STAFF REPORT: 8/13/2025 MEETING

ADDRESS: 4291 CORTLAND & 4510 CORTLAND

APPLICATION NO: HDC2025-00486 (4291 CORTLAND) & HDC2025-00485 (4510 CORTLAND)

SCOPE: REPLACE HANDRAILS/GUARDRAILS, ALTER PORCH STEPS/WINGWALLS, REPLACE WINDOW

Current aluminum-clad wood replacement windows, brickmould, and mullion.

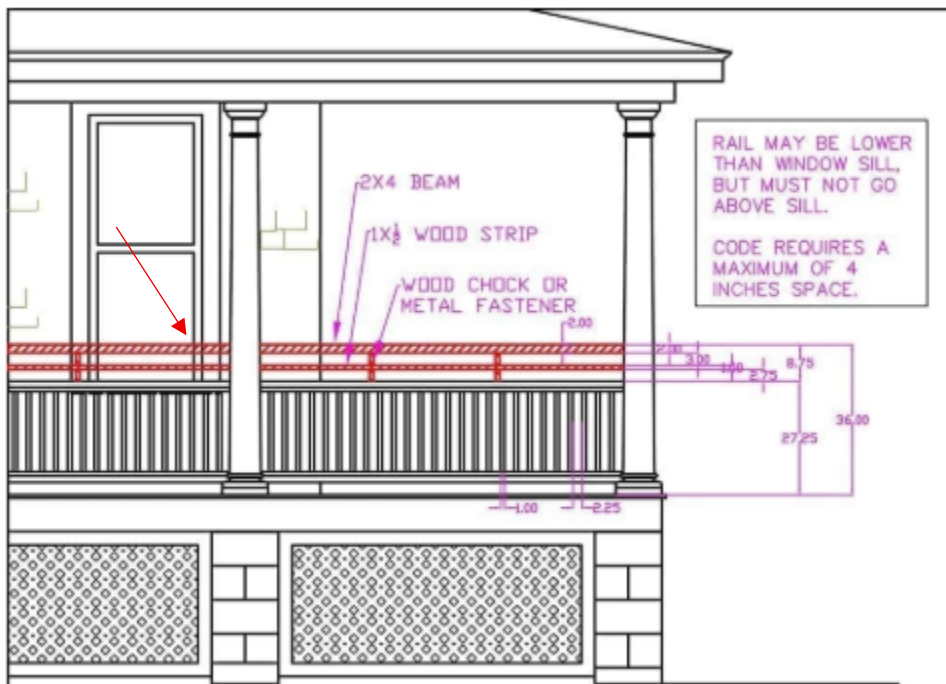
- In 2022, the DLBA noted that the west side casement window at **4510 Cortland's** attic story, gable end at the front façade was no longer extant. HDC staff therefore issued a COA (HDC#2022-7743) to install a new aluminum-clad, wood casement sash within the west side window opening at the attic story, gable end while retaining the existing historic wood brickmould and mullion. Also, the remaining historic casement in the east opening was to be retained and repaired. However, the recent DLBA rehabilitation replaced the remaining historic wood casement window, brickmould and mullion without HDC approval. It is staff's opinion that the work does not meet the Standards because the historic, character-defining wood brickmould, mullion and remaining window appeared to be in good condition prior to their removal. Also, while the new windows are made of wood and match the original in operation and light configuration, the brickmould and mullion are thinner and narrower than the original. As a result, the new window unit appears inappropriately flatter than the original and, as the current brickmould is thinner and narrower, the unit appears to be set more deeply into the opening versus the original (see the below photos)

- The historic, character-defining wood brickmould, mullion and remaining window at **4510 Cortland** front façade, attic story gable end which were removed and replaced without HDC

approval appeared to be in good condition prior to their removal. As such, the elements should have been retained and repaired in kind as required by the Standards. Also, new the brickmould and mullion are thinner and narrower than the original. As a result, the new window unit appears inappropriately flatter than the original narrower and appears to be set more deeply into the opening versus the original

- The historic, character-defining wood brickmould, mullion and remaining window at **4510 Cortland** front façade, attic story gable end which were removed and replaced without HDC approval appeared to be in good condition prior to their removal. As such, the elements should have been retained and repaired in kind. Also, the new brickmould and mullion are thinner and narrower than the original. As a result, the new window unit appears inappropriately flatter than the original narrower and appears to be set more deeply into the opening versus the original.
